PUBLIC INTEREST REVIEW FOR GROUNDWATER APPLICATIONS

SUBJECT: Application G- 17678 Supersedes review of \_\_\_\_\_  
Date of Review(s)

**A. GENERAL INFORMATION:** Applicant's Name: Port of Morrow County: Morrow

### Groundwater Application G-17678, Port of Morrow Morrow County, Boardman Quad

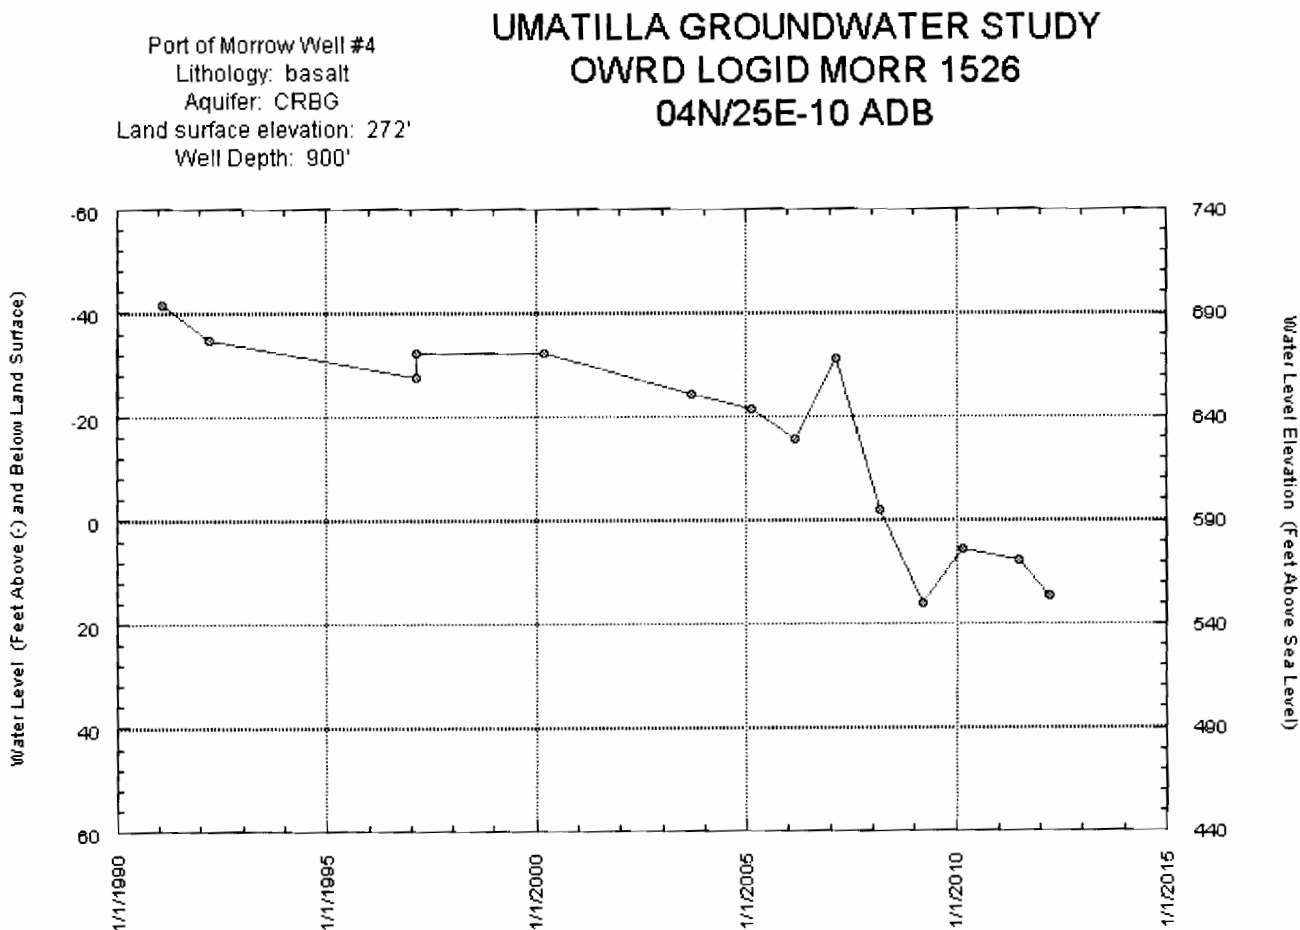
B3. **Ground water availability remarks:** Groundwater level data from MORR 1526, Port of Morrow Well # 4, indicates a decline of about 56 feet over the last 21 years. See attached graph. Existing pumpage under permit G-10975 averaged 1473 acre-feet per year from 1992 through 2004 (data submitted by Port). Permit G-10975 allows up to 3226 acre-feet per year. Under permit G-10975, the Department “shall” regulate use if the groundwater level in Well #4 exceeds 200 feet below land surface. At the current rate of decline, the water level will reach 200 feet in about 60 years. As the amount of pumpage increases within the existing water right, the rate of decline will increase, reducing the time to reach 200 feet.

The new application is for a large rate and volume of water for industrial use – 4.95 cfs (2420 gpm) and 3584 acre-feet. The groundwater resource cannot sustain the current use. Current use could more than double under the existing water right.
